July 26, 2012

**Re: Revised Permit Application and Response to Completeness Determination
KM Liquids Terminals LLC – Galena Park Terminal
Galena Park, Harris County
TCEQ Customer Reference Number: CN603254707
TCEQ Regulated Entity Number: RN100237452**

**March 2012
Revised July 2012**

Figure 4-3
Material Streams

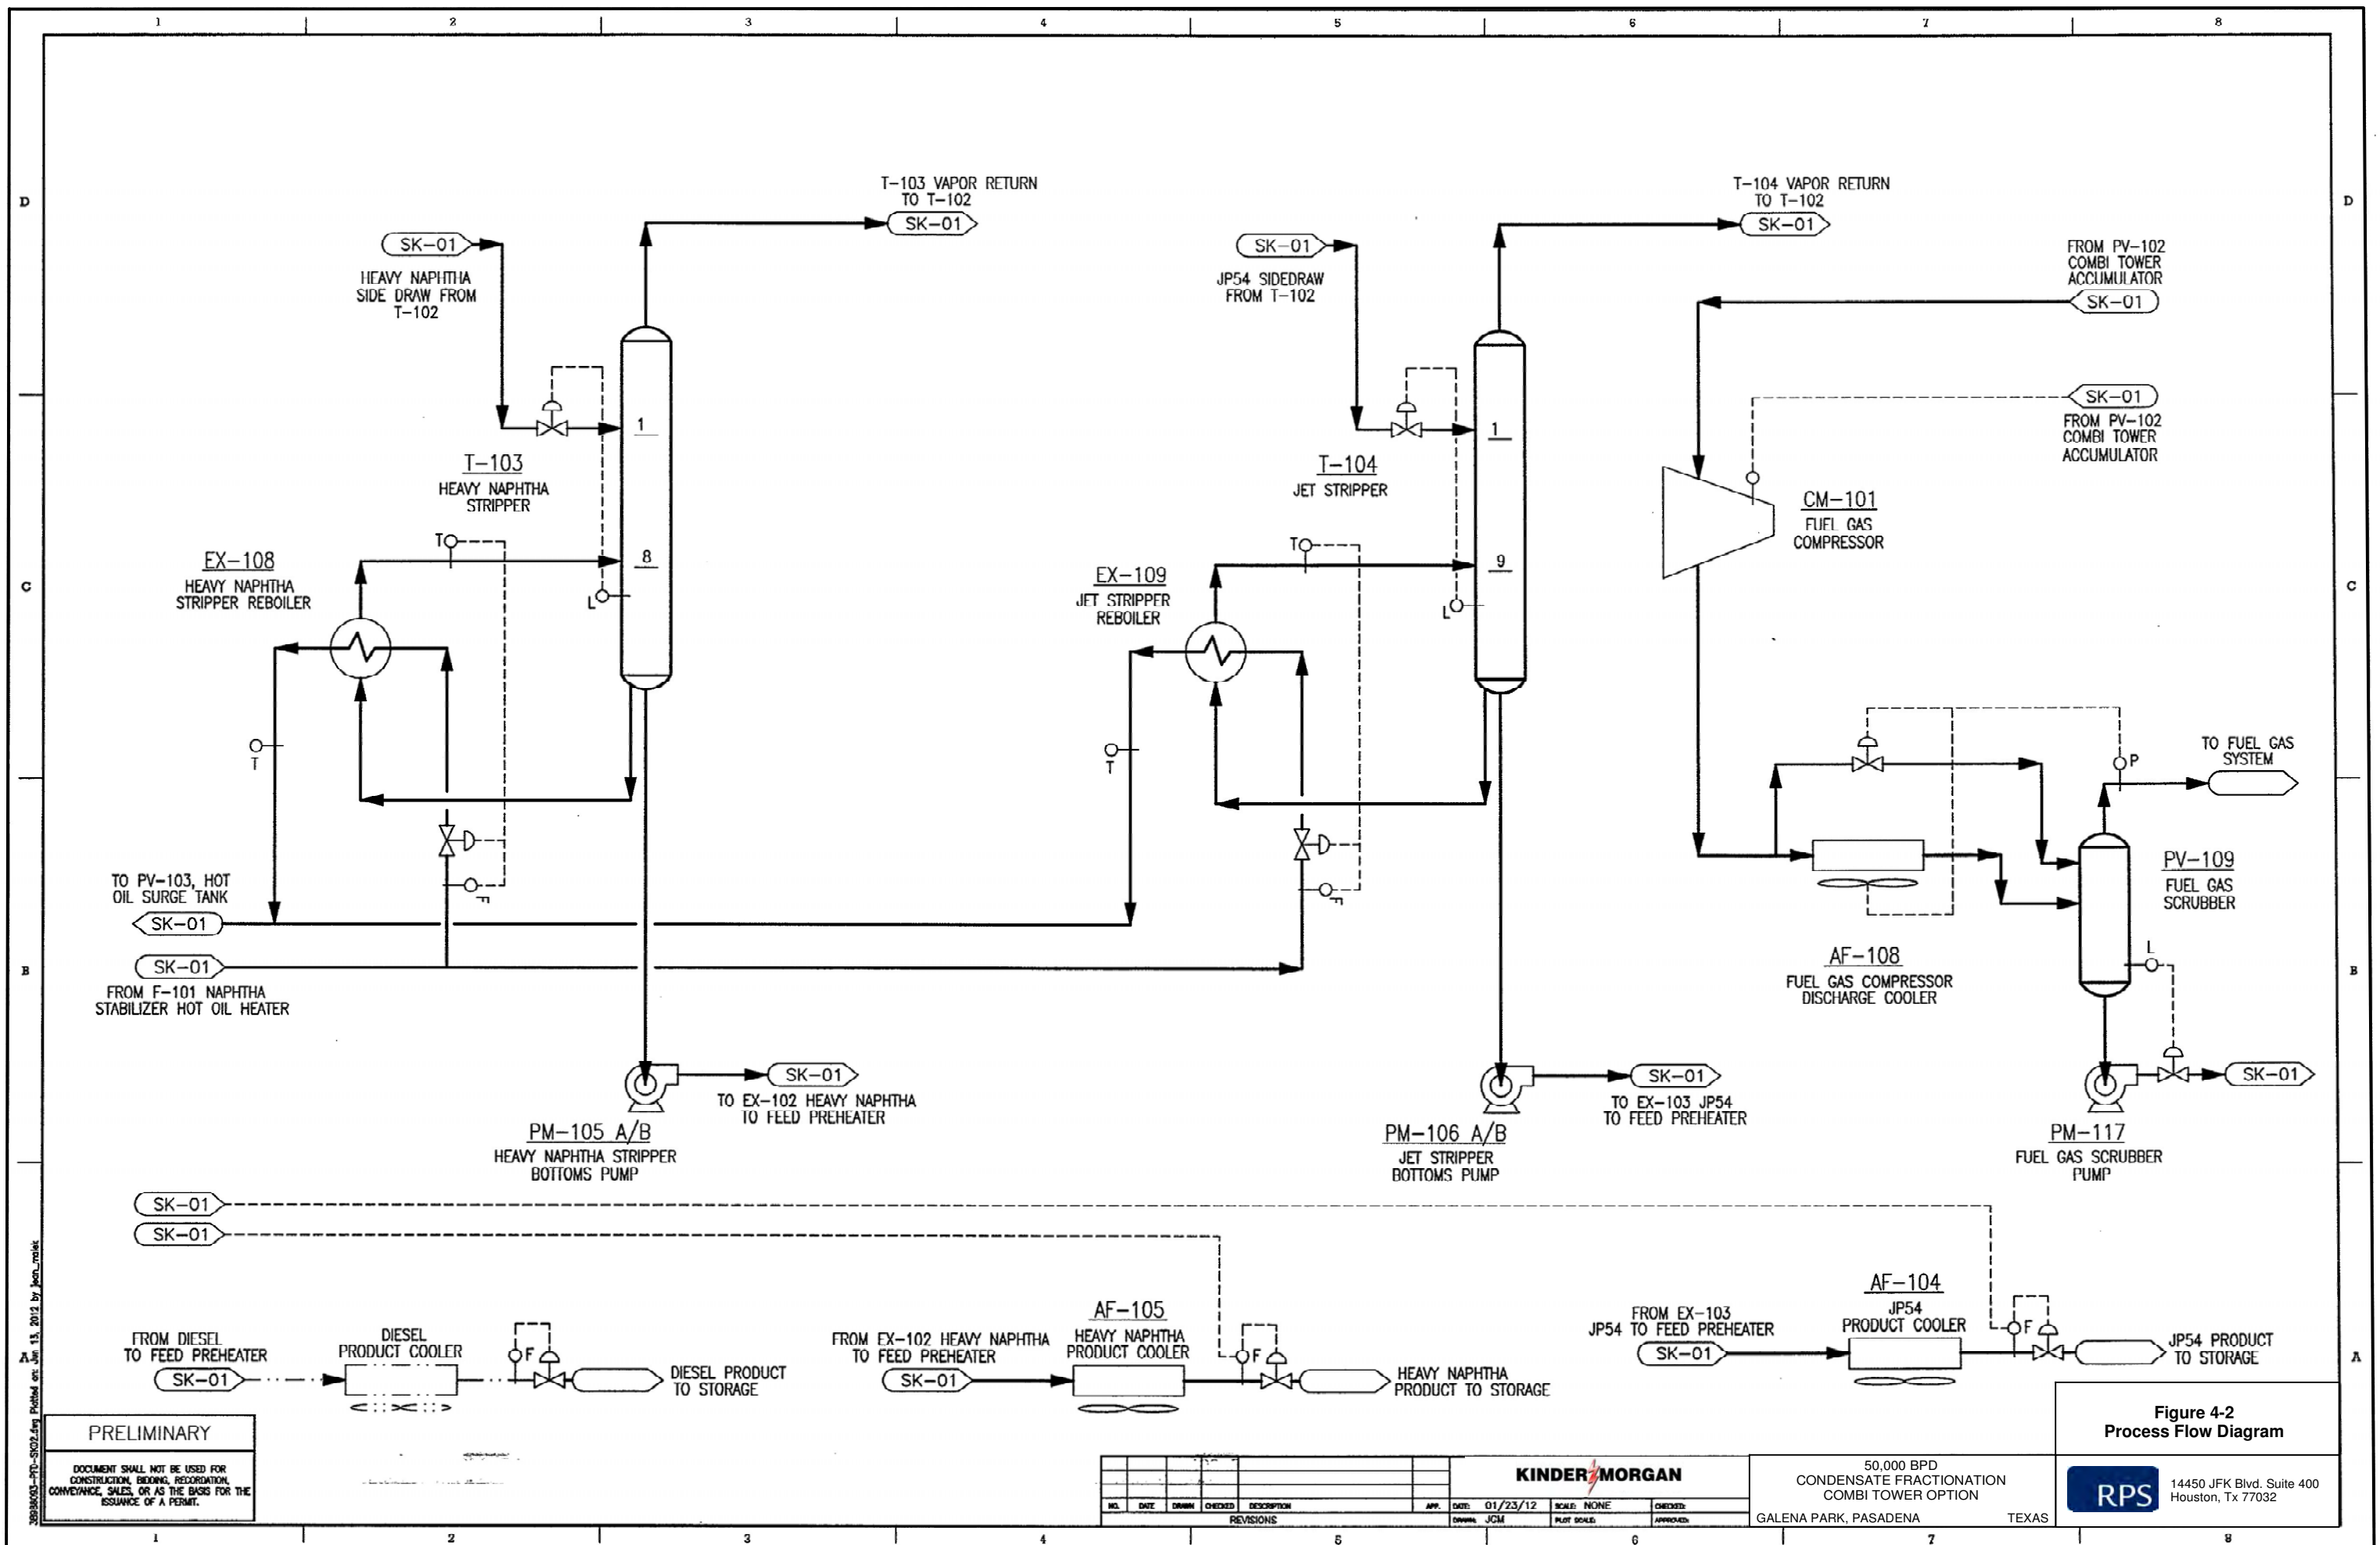
1. EPA requests a detailed description of the distillation process as it pertains to the proposed condensate splitter. This should include a list of all the potential hydrocarbon streams and all the distillates produced. Please indicate which of the four heaters is capable of processing which hydrocarbon streams and the resulting products from the distillation. Additionally, indicate which distillates are considered "overhead product" and which are derived from the heavier condensate fraction. A table format is advisable.

The additional information requested in this item is provided in the enclosed revised permit application. An updated process description, including a detailed description of the distillation process has been incorporated into Section 4 of the enclosed revised permit application. Figures 4-1 and 4-2 provide an overall process flow diagram and have been revised to include feed and product stream names. Table 4-1 and Figure 4-3 have been added to the application and provide feed and product stream specific information in table format.

Note that the design of the proposed condensate splitter has changed since the initial permit application submittal. The updated design consists of two process heaters rather than the originally proposed four process heaters; however, the overall heat capacity has increased. The process description referenced above includes the updated condensate splitter design details.
